1st Further Information

**Proposed Temporary Warehouse (excluding Dangerous Goods Godown) with Ancillary Facilities
and Associated Filling of Land for a Period of 3 Years in "Agriculture" Zone,
Lot 207 in D.D. 38, Man Uk Pin, New Territories**

(S.16 Planning Application No. A/NE-MUP/235)

Response to CEO, CEDD comments on 25 June 2026.

Appendix E

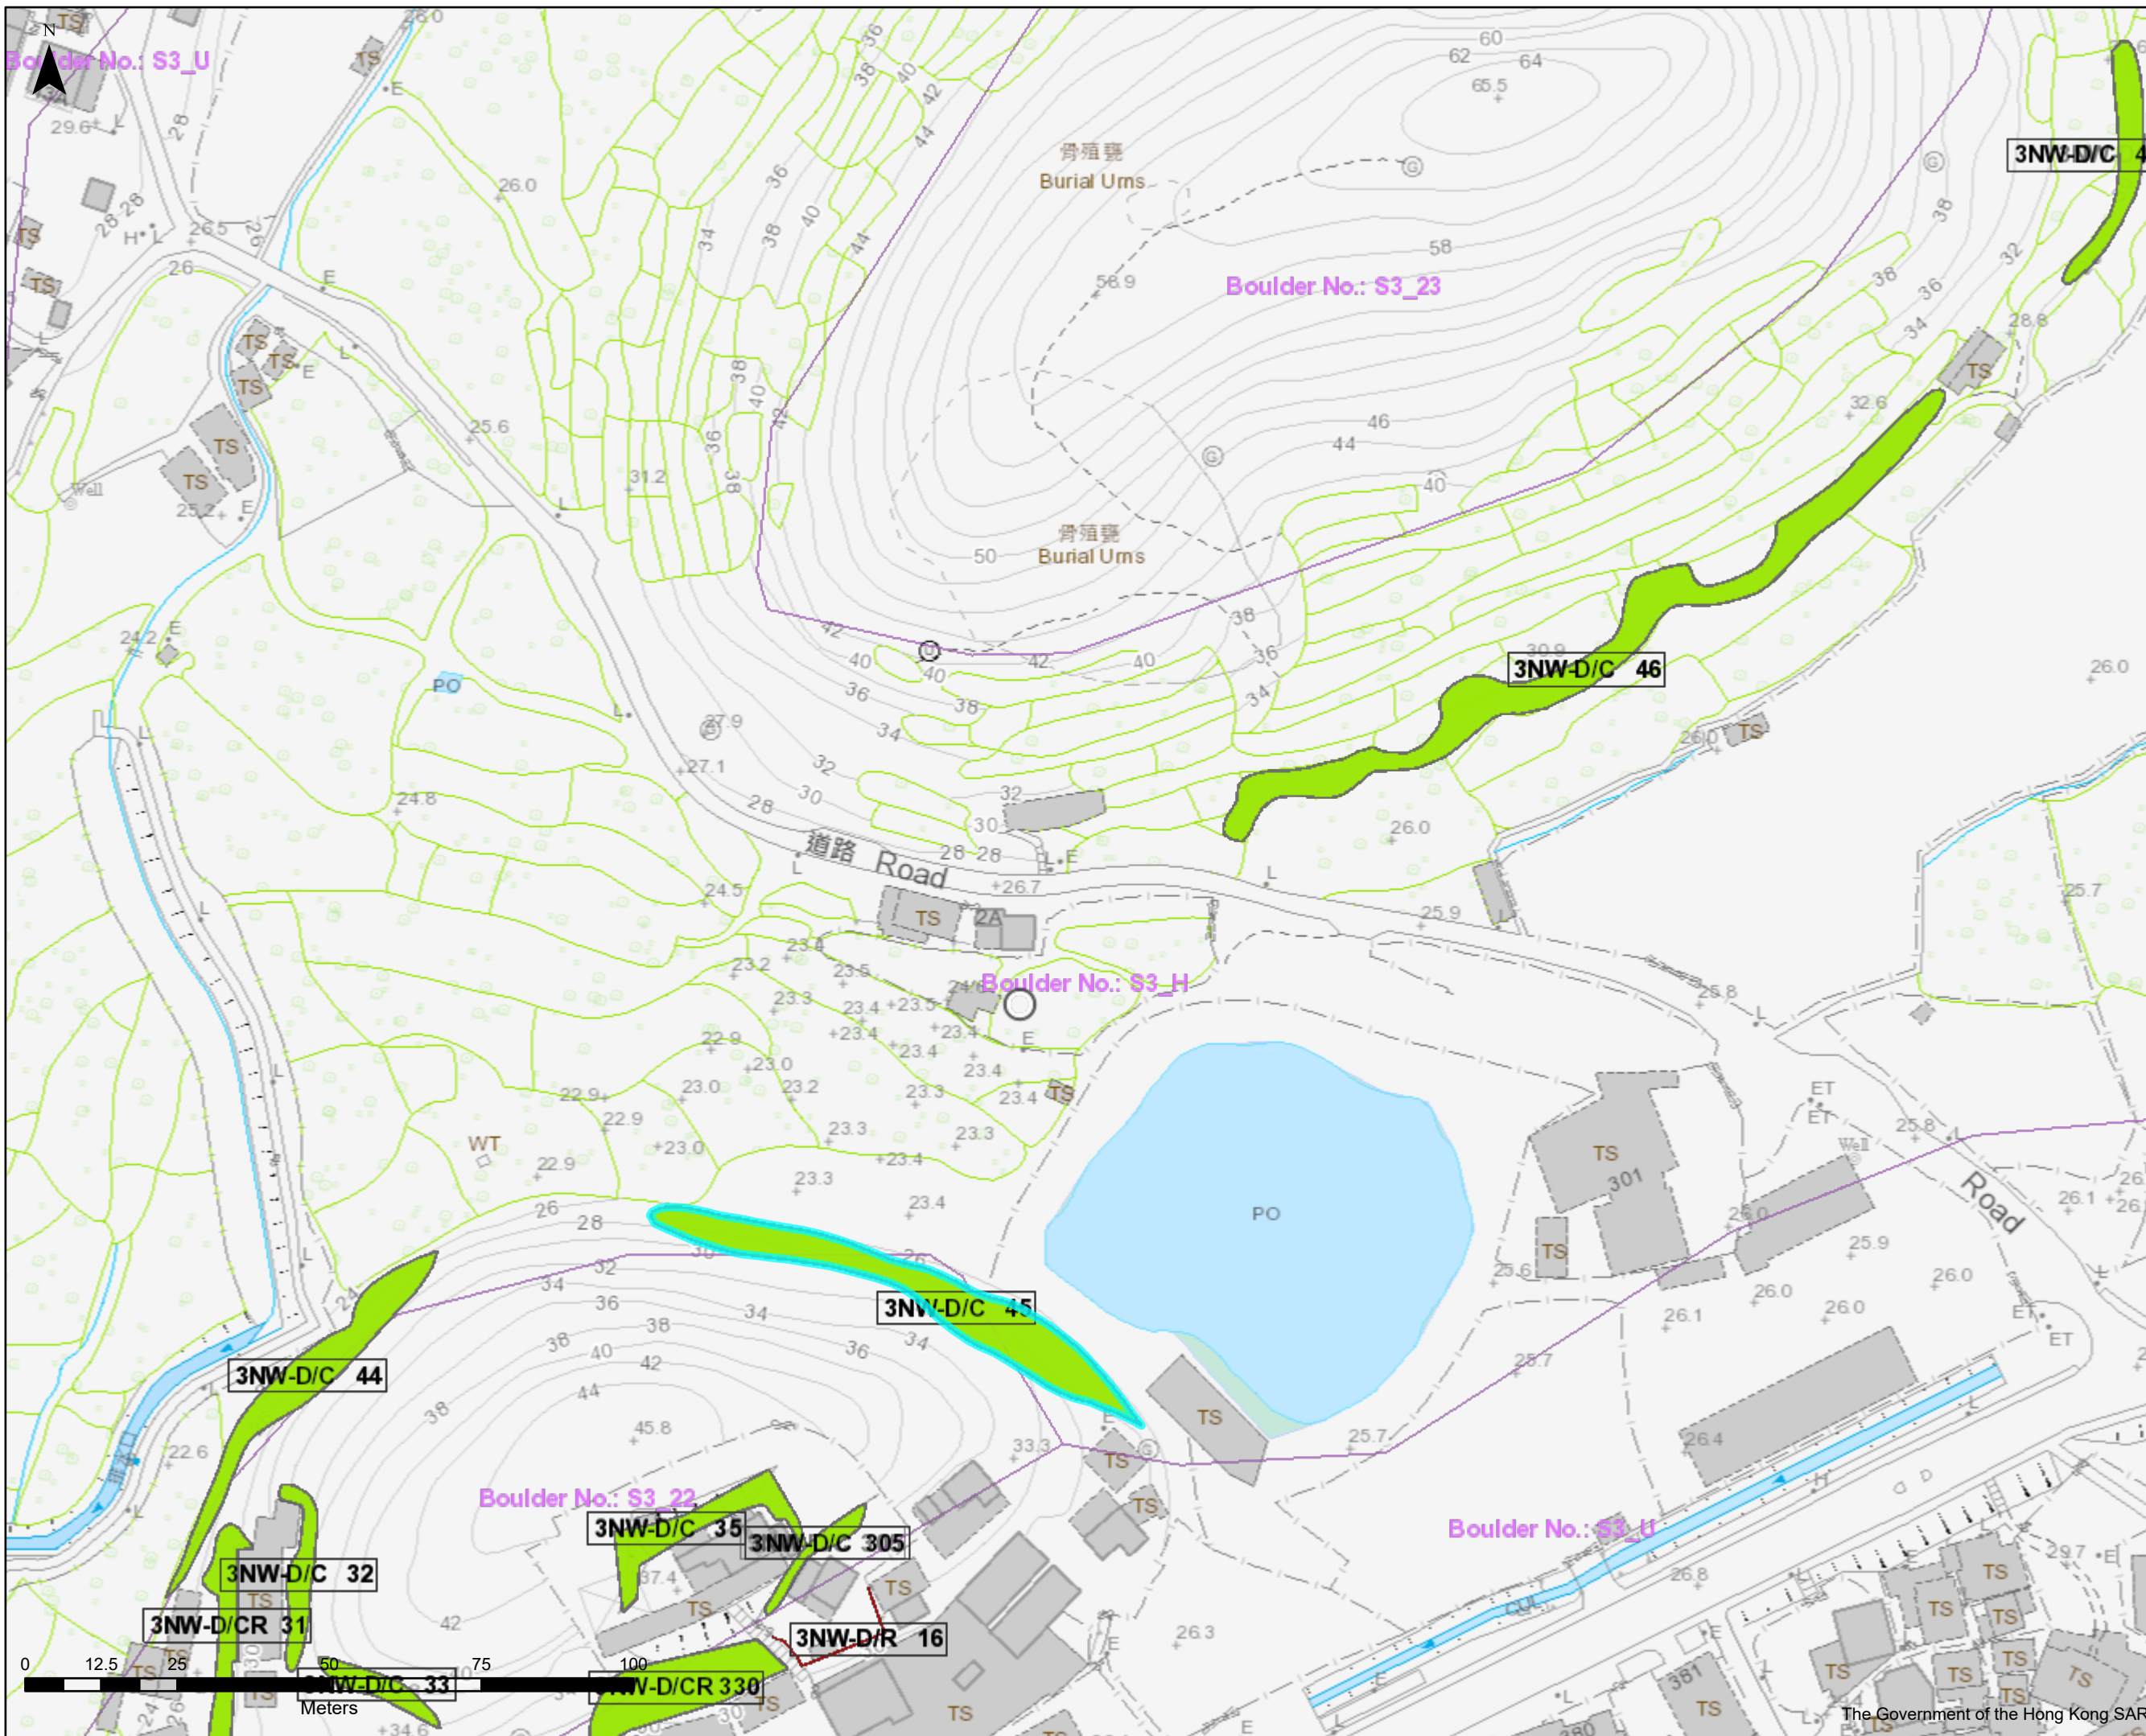
Section 3.1.3 of the GPRR - the applicant should discuss the boulder field inventory information for the natural terrain overlooking the subject site;	Noted. The discussion of boulder field inventory information has been revised accordingly in Section 3.1.3.
section 4.2.1 of the GPRR - relaxation of angular elevation of the Alert Criteria from 20 degrees to 25 degrees could not be applied for the natural terrain to the north of the subject site as the natural terrain is affected by human disturbance (e.g. terraces) and is considered to be a Hillside Pocket; and	Noted. The angular elevation of the Alert Criteria is revised to 20 degrees.
Section 4.2.2 of the GPRR - the applicant should discuss the facility group of the proposed site office, washroom and parking space of the proposed use.	Noted. Referring to the revise Layout Plan, only Loading/Unloading space (LGV) and warehouse for goods storage are proposed. The discussion of the facilities are revised in Section 4.2.

The Site itself not fall in any Boulder Field Inventory but Catchment OH1 (Natural openhill terrain) is fall within Polygon No.S3-23 of the Boulder Field Inventory. The extent of Boulder Filed Inventory is shown in **Appendix E**.
